ADVISORY COMMITTEE ON REACTOR SAFEGUARDS
UNITED STATES ATOMIC ENERGY COMMISSION
WASHINGTON, D.C. 20545

THEOFANOUS' COMMENTS ON GRAND GULF

On February 5, 1974, I received a telephone call from Dr. Theofanous in which he identified the following list of items as still open to resolution:

RECIRCULATION LINE BREAK

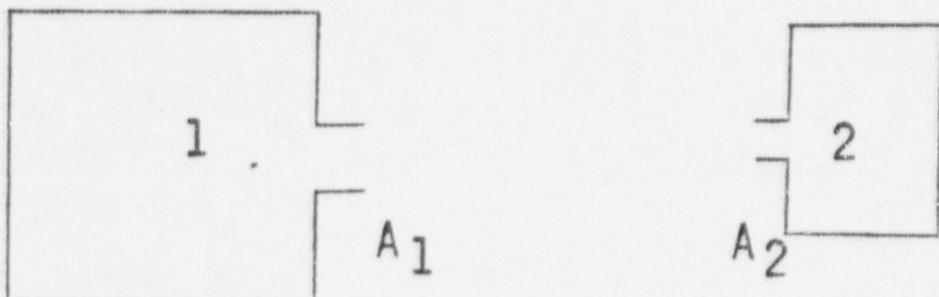
- 1) LONG TERM MODEL IS ACCEPTABLE
- 2) USE OF .5 AREA COEFFICIENT IN SHORT TERM MODEL HAS NOT BEEN JUSTIFIED
- 3) COEFFICIENT OF 1.0 WOULD BE ACCEPTABLE
